Access Compliance Report Public Rights-of-Way (Curb Ramps)

Intersection ID: 9865 Main Street: FREEDOM_DR Cross Street: N_I-85_RA Location: SE

ADA ID: 411310AFC6F6 Ramp Type: Perp Initial Pass/Fail: Fail Overall Compliance: No Severity Score: 21.25

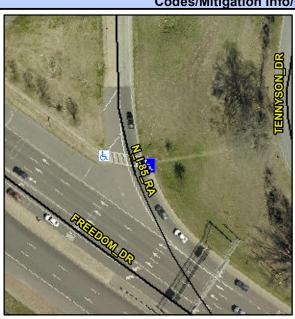
Possible Solutions:						
Remove & Replace Entire Ramp.						
·						
Surveyor Notes:						
N/A						
PROW/ADA:						
Not Found, R304.5.1, R304.2.2

Field Measurements/Component Compliance									
Comp	liance Description	Data	Comp	liance	Description	Data			
N/A	Ramp Length (in)	59.0	No	Ramp	Slope (%)	10.2			
No	Ramp Width (in)	43.5	Yes	Ramp	XSlope (%)	1.6			
N/A	Flare Type LT	N/A	N/A	N/A Flare Type RT		N/A			
N/A	Flare Slope LT (%)	N/A	N/A	N/A Flare Slope RT (%)		N/A			
N/A	Flare Traversable LT?	N/A	N/A	Flare	Traversable RT?	N/A			
N/A	Landing Length (in)	N/A	N/A	DWS	Provided?	N/A			
N/A	Landing Width (in)	N/A	N/A	DWS	Contrast?	N/A			
N/A	Landing Slope (%)	N/A	N/A	DWS	Length (in)	N/A			
N/A	Landing X Slope (%)	N/A	N/A	DWS	Full Width?	N/A			
N/A	Landing Curb? (Y/N)	N/A	N/A	DWS	Offset (in)	N/A			
N/A	Shared Landing?	N/A							
N/A	Gutter Ponding?	N/A	N/A	Gutte	r Slope (%)	N/A			
N/A	Gutter Lip Ht (in)	N/A	N/A	Gutte	r X Slope (%)	N/A			
N/A	Painted X Walk1?	Yes	N/A	Paint	ed X Walk2?	N/A			
	X Walk 1 Direction	To NW		X Wa	lk 2 Direction	N/A			
N/A	X Walk 1 Width (in)	103.0	N/A	X Wa	lk 2 Width (in)	N/A
